VISUAL SITE INSPECTION REPORT – 2016

HOOSIER ENERGY REC
MEROM GENERATING STATION
AREA 3 RESTRICTED WASTE LANDFILL
MEROM, INDIANA

ATC PROJECT NO. 170LF00320

JANUARY 18, 2017

2016 LANDFILL INSPECTION AREA 3 CELL 1 MEROM GENERATING STATION				Drawing Title:
<div style="font-size: 48px; font-weight: bold; margin: 0;">1</div>				Sheet:

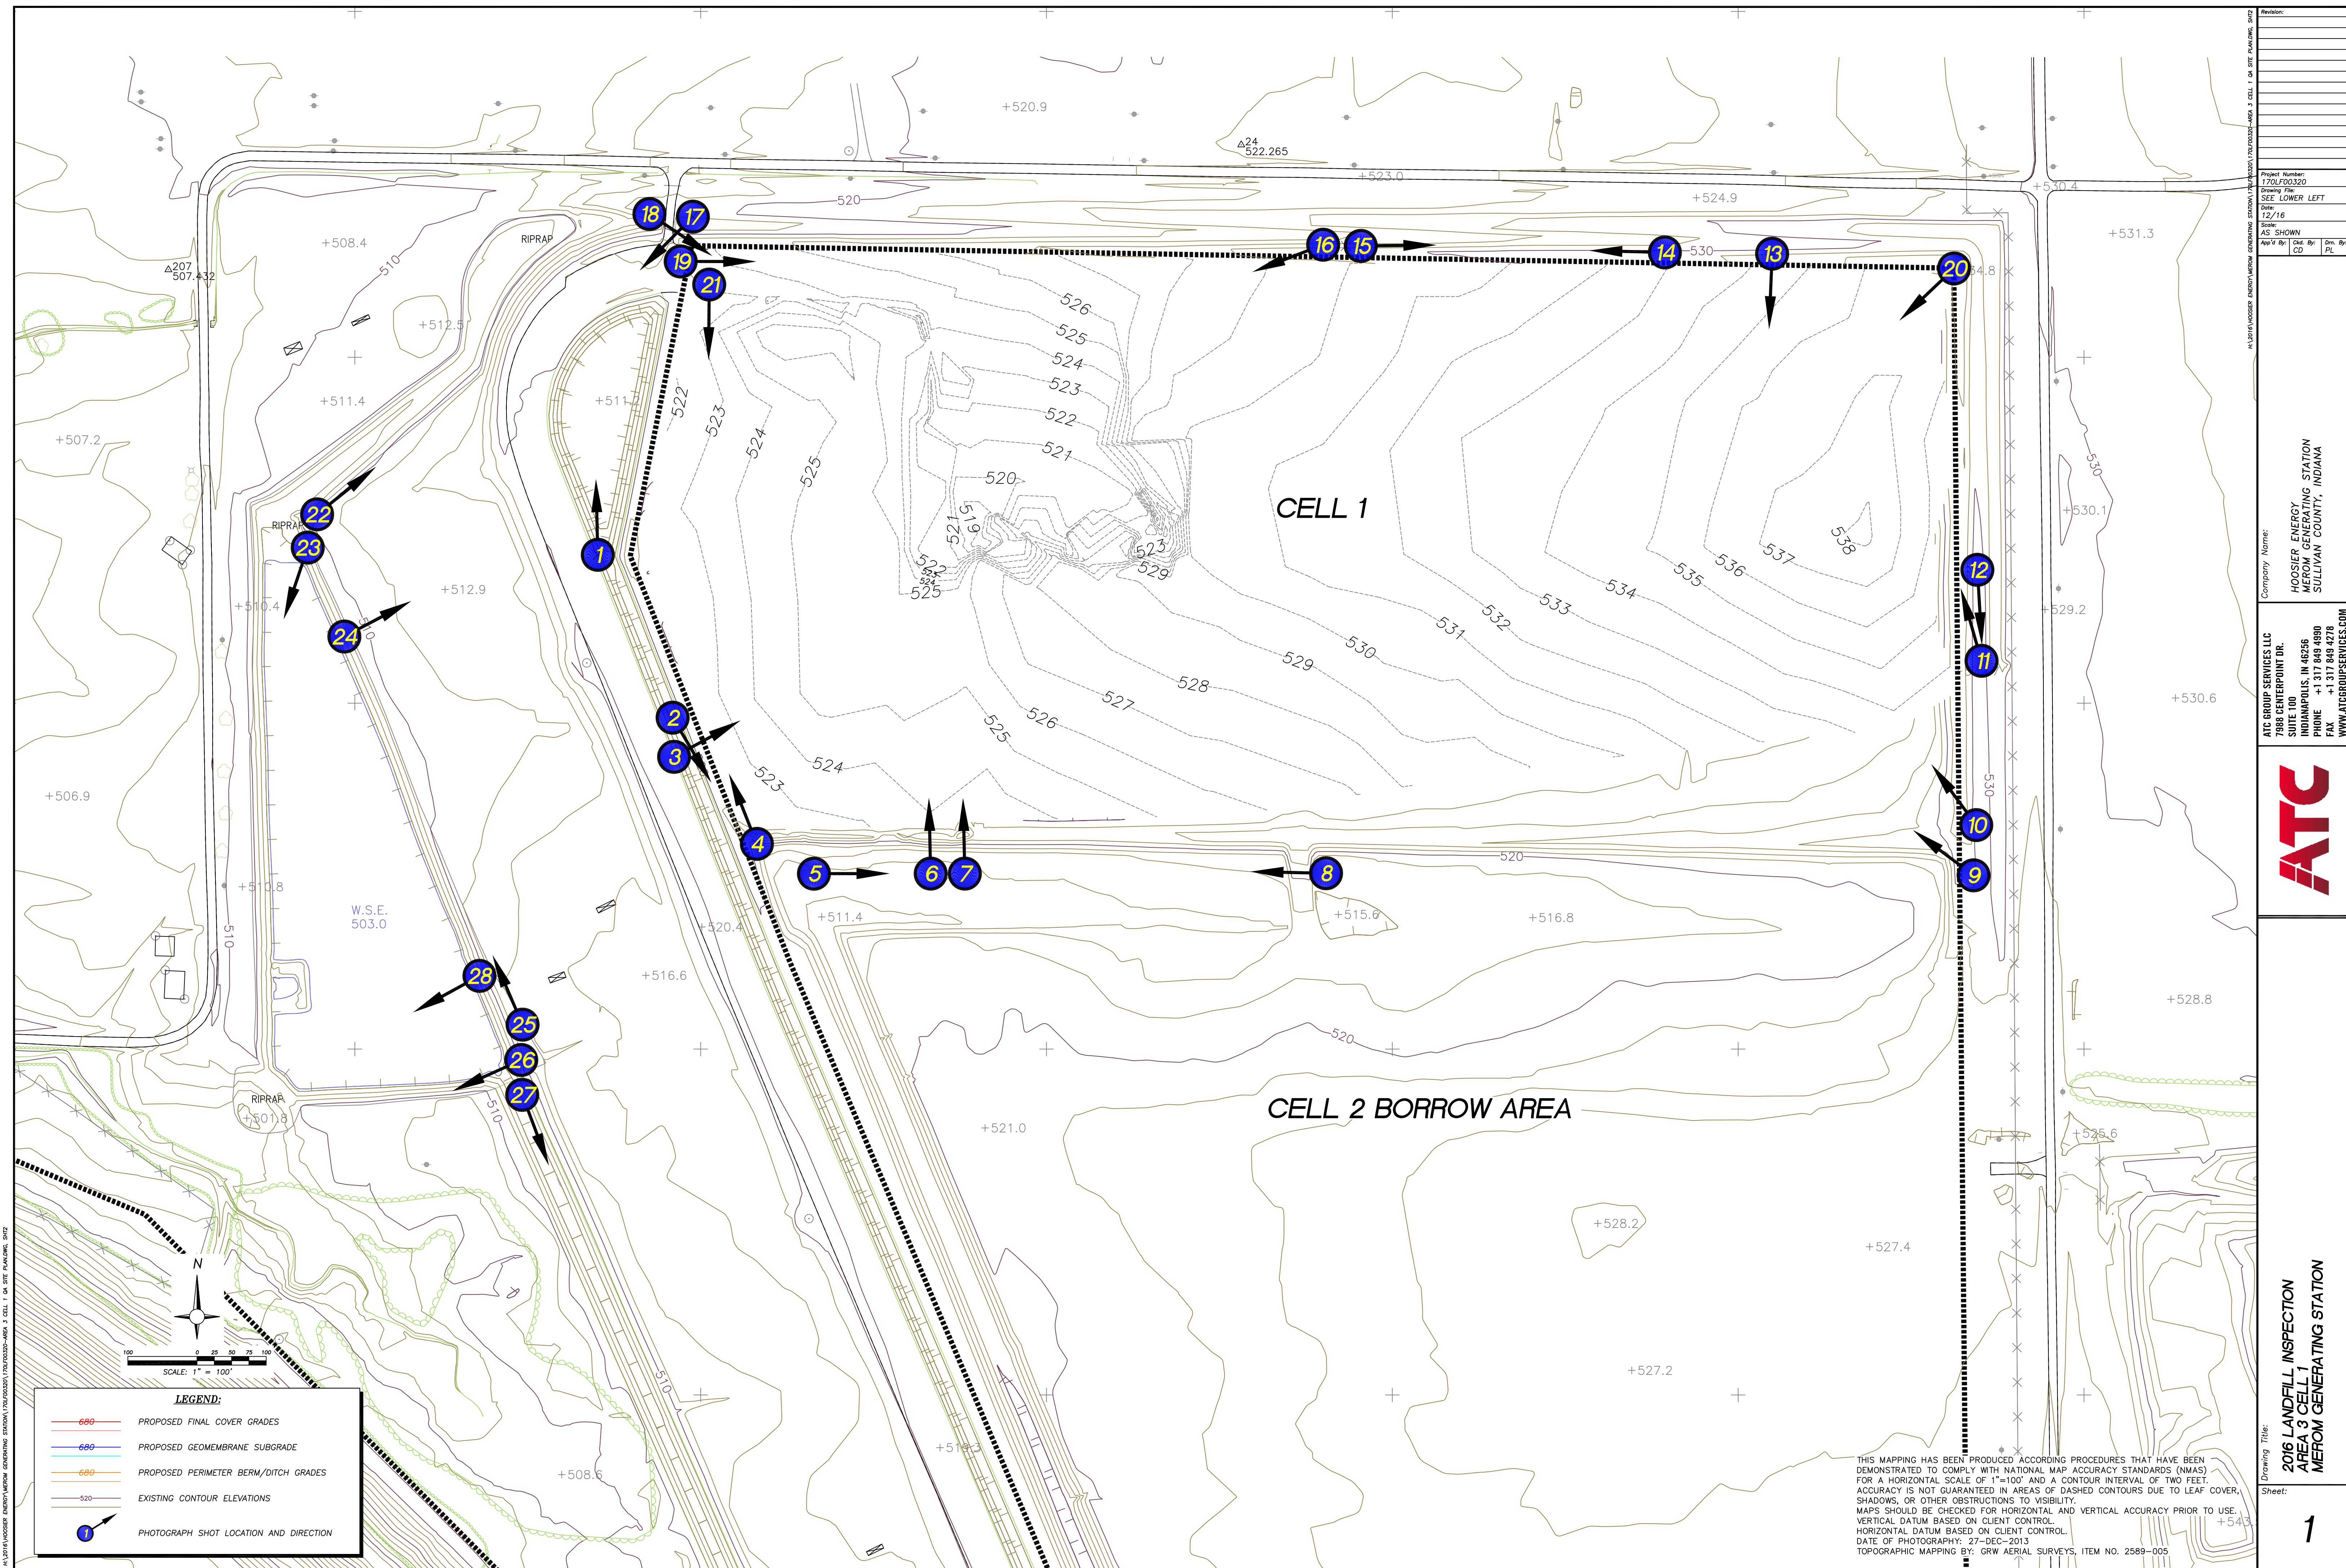
- 1) Location 1 encountered the sediment trap basin. The basin appears to be functioning properly to catch runoff from haul roads.

- 2) Locations 2, 3, and 4 encountered soil slopes that are lightly vegetated and have some erosion rills due to surface water runoff.

- 1) Locations 5, 6, 7, and 8 encountered soil slopes that are lightly vegetated with some erosion due to surface water runoff. Location 6 has a small area of exposed geosynthetic liner material.

- 2) Location 9 encountered entrance / exit haul road. The road is a dirt road.

- 1) Locations 10, 11 and 12 encountered soil slopes that are well graded intermediate soil cover with light vegetation at the toe. These slopes have some erosion rills due to surface water runoff.

- 1) Locations 13, 14, 15, and 16 encountered lightly vegetated soil slopes with some erosion rills due to surface water runoff.

- 2) Location 18 encountered an area where water has eroded a drainage ditch.

- 1) Location 20 encountered some areas where Pozotec could be eroded by wind.

- 2) Location 21 encountered areas of gully erosion in Pozotec material.
Recommendation: Regrade CCR to diminish erosion.

- 1) Locations 22 and 23 encountered the riprap channel leading to the sedimentation basin. The riprap is in good shape.
Recommendation: None at this time.
- 2) Location 24 encountered areas of erosion at the top edge of the riprap cover along the east embankment slope of the sedimentation basin.
Recommendation: Regrade and seed along top edge of basin.
- 3) Location 25 encountered the east embankment of the sedimentation basin. The slope appears stable.
Recommendation: None at this time.
- 4) Location 26 and 27 encountered the south concrete lined ditch entrance to the sedimentation basin. Small debris accumulation and vegetation growth in the channel.
Recommendation: None at this time.
- 5) Location 28 encountered the drop inlet of the sediment pond. The inlet appears to be functioning properly with no blockages around the trash guard.
Recommendation: None at this time.

Recommendation: Continue a regular maintenance program to clean out and remove sediment from the trap basin so that it does not become full.

Recommendation: Regrade and overseed the areas where erosion rills are present.

Recommendation: Regrade and overseed the areas where erosion rills are present.

Recommendation: Consider adding course aggregate to entrance and exit haul roads.

Recommendation: Regrade and overseed the areas where erosion rills are present.

Recommendation: Regrade and overseed the areas where erosion rills are present.

Recommendation: This section of drainage ditch should be regraded, protected with riprap, and revegetated.

Recommendation: Flatten the CCR stockpile sideslopes.
